Lot 154 DC
490 Duncan Creek Rd., Lillington, NC 27546

9-13-24- Redlines - JJ

10-21-24 Pantry shelves | Cabinet skin |
No owners bath accessories CW

THE SMITHFIELD - RH

OPT. KITCHEN W/ EXTENDED CAFE
SCALE: 1/8"=1'-0" ON 11x17, 1/4"=1'-0" ON 22x34

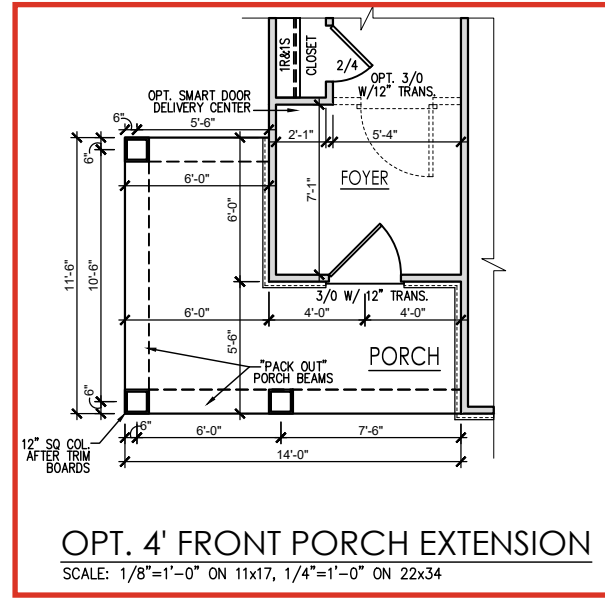
NO KNEEWALL | CABINET SKIN

wooden pantry shelves

OPT. OWNER'S BATH & BEDROOM #2
SCALE: 1/8"=1'-0" ON 11x17, 1/4"=1'-0" ON 22x34

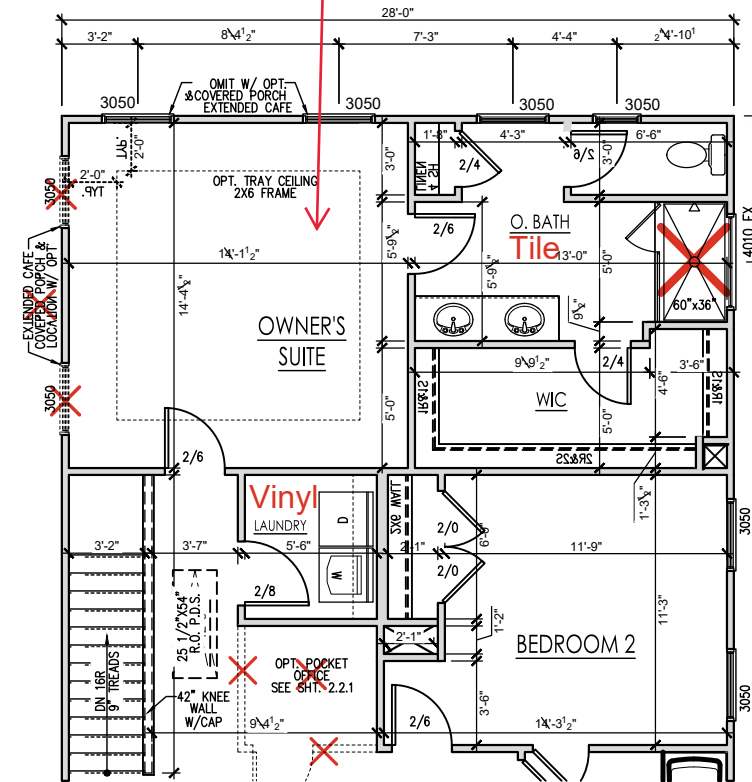
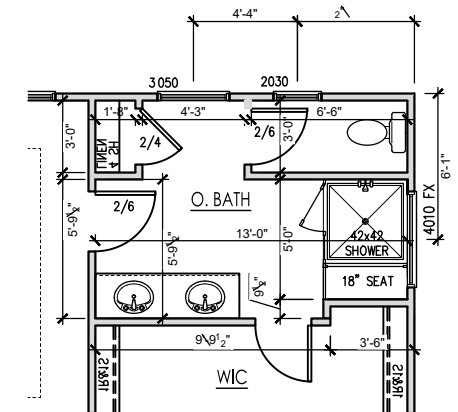
DO NOT INSTALL BATH ACCESSORIES IN OWNERS BATH ONLY

SECOND FLOOR PLAN 'FRENCH COUNTRY'
SCALE: 1/8"=1'-0" ON 11x17, 1/4"=1'-0" ON 22x34

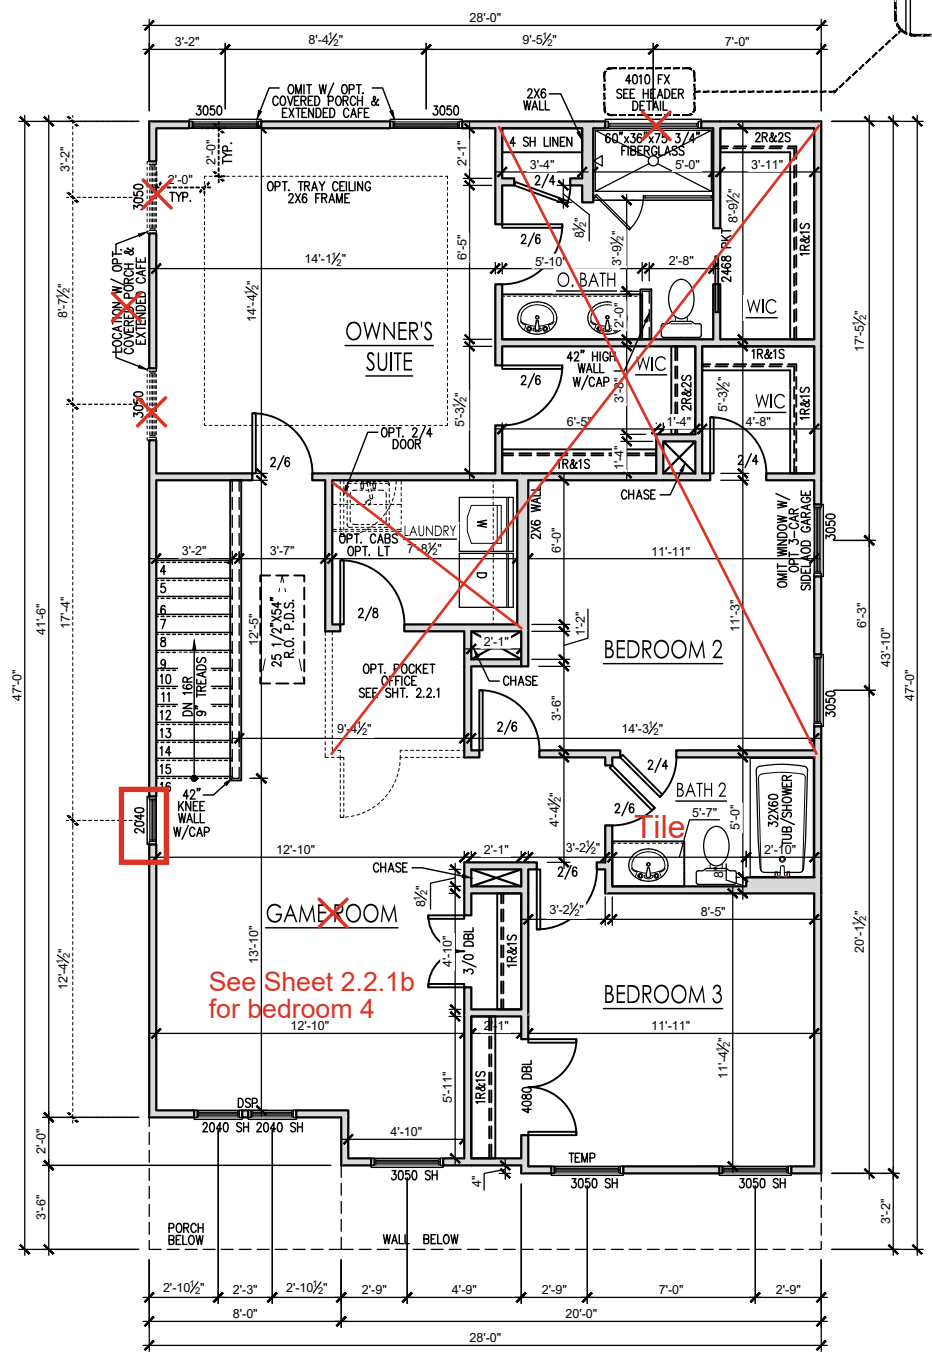
HEADER DETAIL
NOTE: NO TOP PLATES OVER LVL - ADD METAL STRAPPING AT CORNERS
